State Significant Development – Brewongle Solar Farm (SSD-64834490)

Council has had an opportunity to review the EIS as submitted and provides the following comments as to the matters contained within.

PERMANENT ON SITE INFRASTRUCTURE

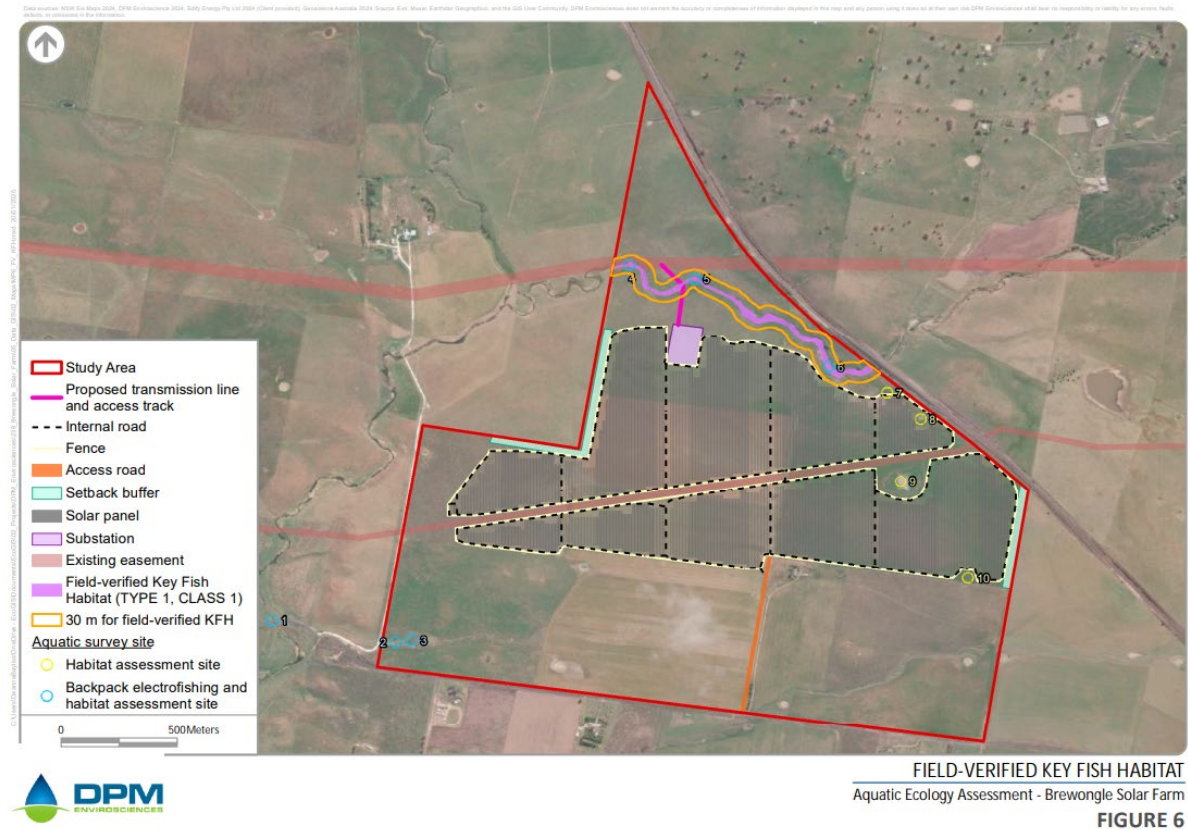
The proposal includes permanent infrastructure with potential for generating human waste (toilets/showers etc). These facilities should be supported by an On Site Sewage Management designed and installed in accordance with Geotechnical Investigations.

Viewpoint P8
Detailed viewpoint assessment

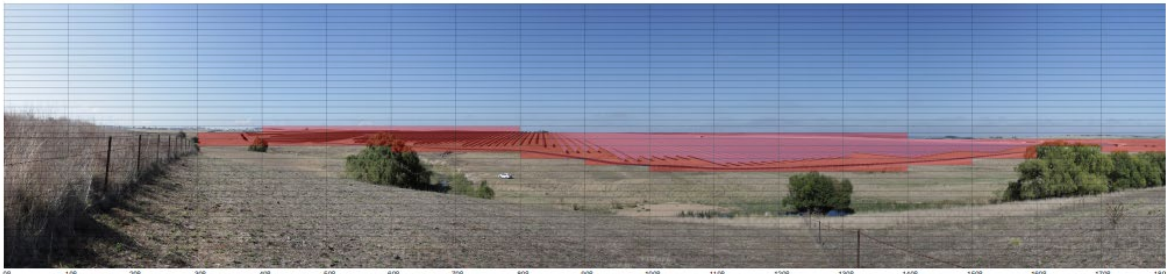
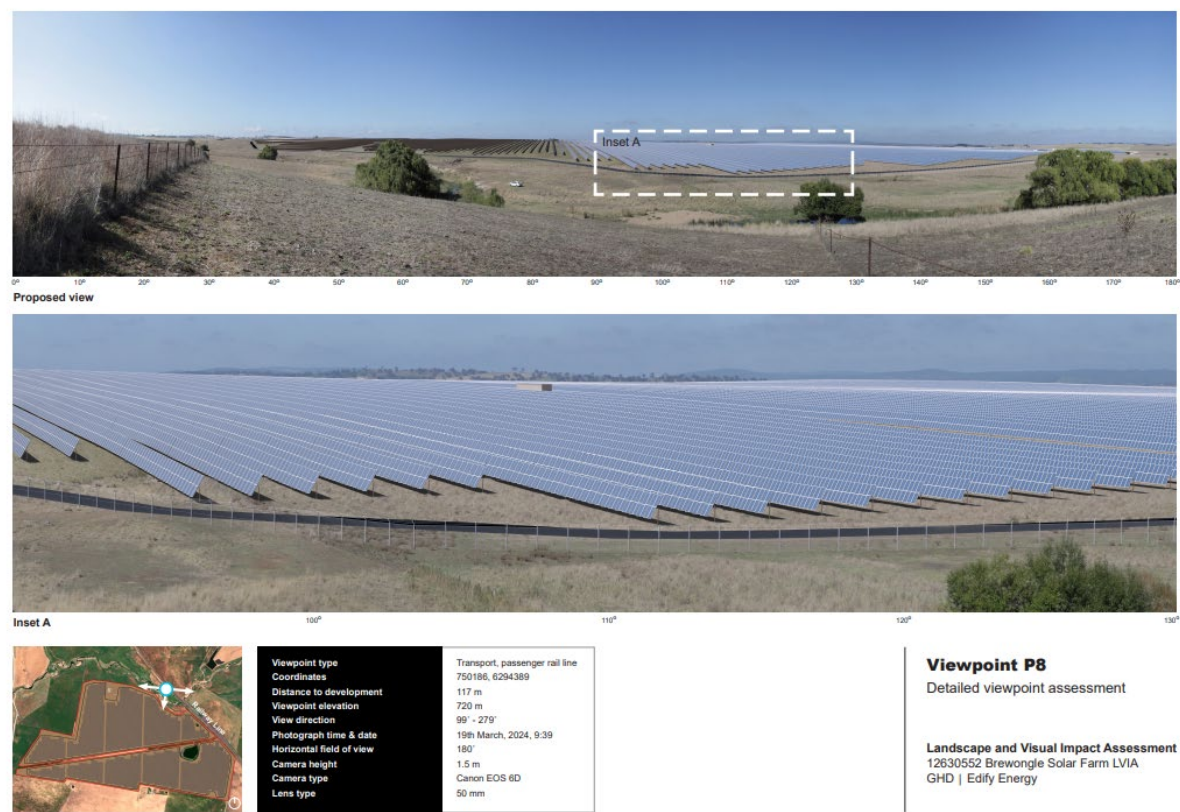
The Technical Supplement requirements have not being applied to the views from the Main Western Railway. The rationale for not undertaking mitigation is not particularly robust given:

- Proximity is 117m and the magnitude of impact is assessed as large (p54)
- The elevated nature of the Rail line meaning that the *“magnitude of views from the actual rail line is likely to be greater than assessed, proving difficult to mitigate in the short to medium term with on site perimeter planting”*.

- The fact that trains may be travelling at high speed is no different to a vehicle travelling along Tarana Road. The latter warranting a 500m setback and screen planting.

The conclusion that magnitude of the impact is in fact be greater than assessed does little to support the recommendation that no mitigation is warranted.

The Technical Supplement recommends that *“if the available mitigation options would not be effective in reducing impacts or are unsuitable due to the nature of the impact (e.g. screening would result in the obstruction of views), then project redesign and/or impact agreements should be considered”*. If the available mitigation measures would not be effective the approach should be project redesign rather than excluding that impact.

It is also worth noting that the representative location shown for viewpoint 8 (from the Main Western Railway) is at point where the solar panels are located 117m from the line itself. At points to the east of this location the solar panels are located immediately adjacent to railway line for a distance of approximately 750m. It is unclear whether the panels would be visible from this section of the railway line. No mitigation or setback is proposed along this section.

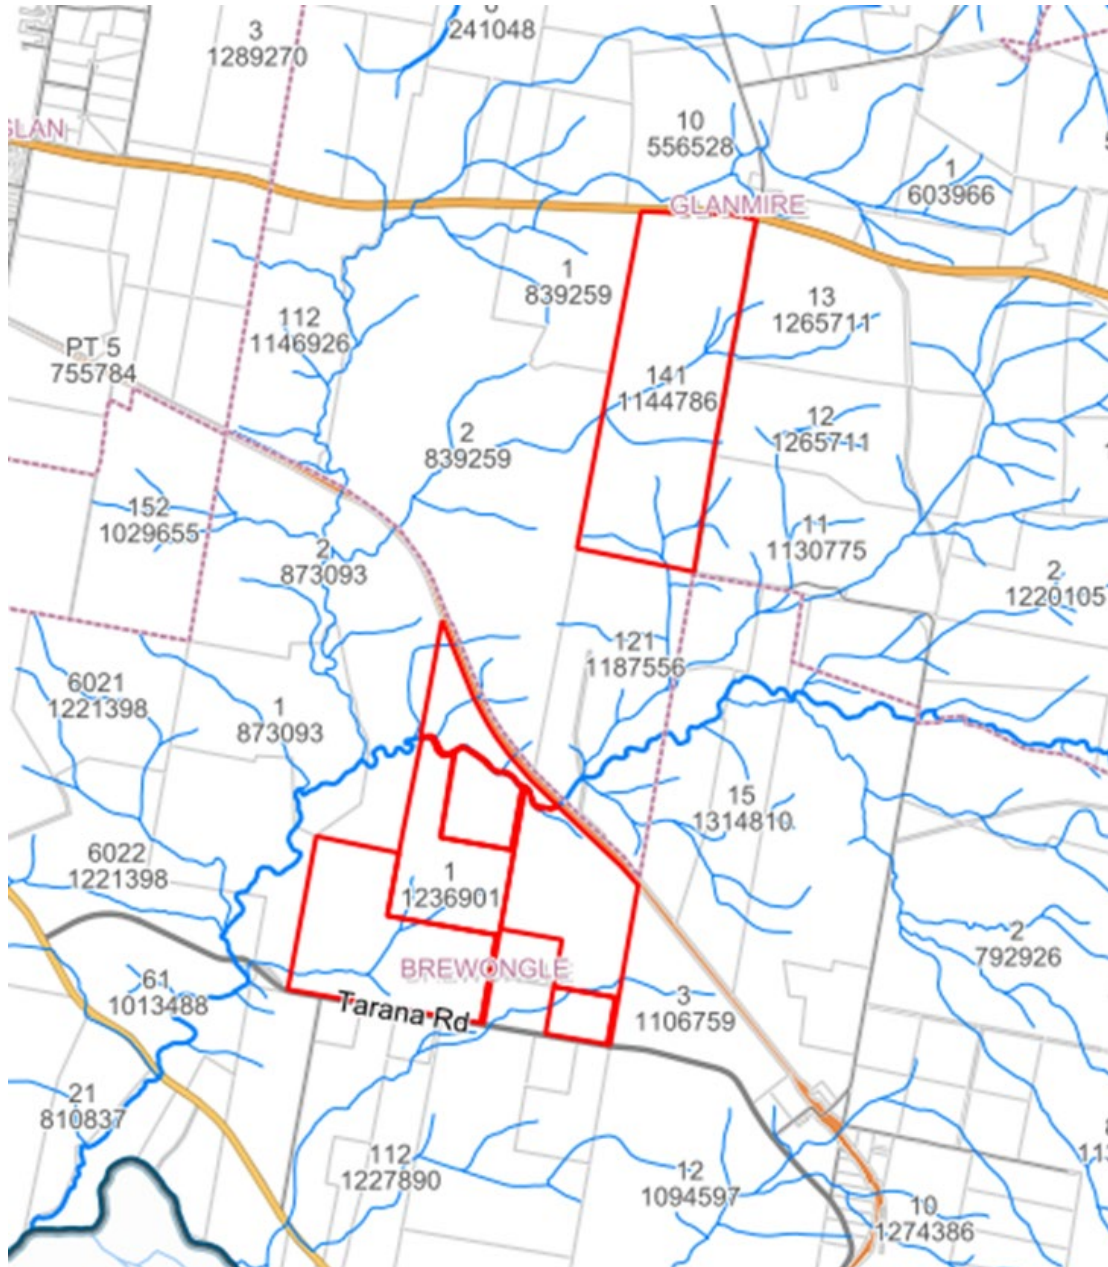
Whilst there is reference to consideration of the cumulative impacts of other developments the modelling does not appear to include the impacts from the Glanmire Solar project (approved).

Both the Glanmire Solar and Brewongle Solar proposals drain to Salt Water Creek, to the bridge on Tarana Road (to be replaced) and beyond to O'Connell Road and the Macquarie River. The respective project locations and tributaries are below.

Whilst assumptions have been made on the impact of additional flooding on the upgraded Salt Water Creek bridge that does not appear to include any cumulative impacts with Glanmire Solar.

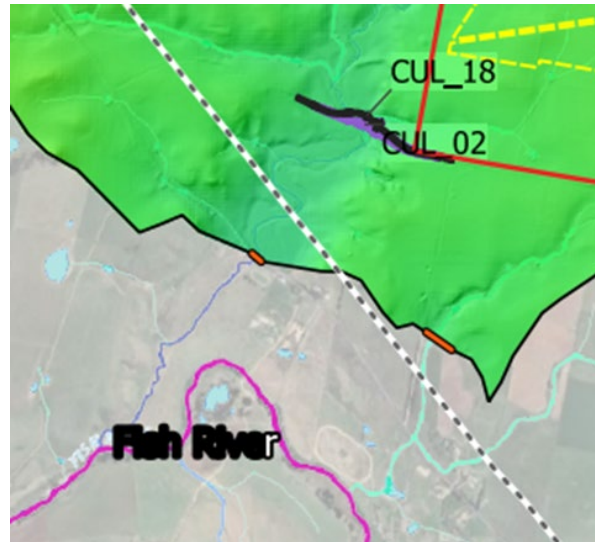
Concerns have been expressed to Council by residents located on southern side of O'Connell Road whose properties are currently impacted by flooding from Salt Water Creek. Those residents have expressed concerns that the project (together with the Glanmire Solar project) will exacerbate those issues. Those properties are beyond the current modelled extent which currently ends at the bridge over O'Connell Road.

The potential cumulative impacts on the properties to south of O'Connell Road should be modelled and assessed.
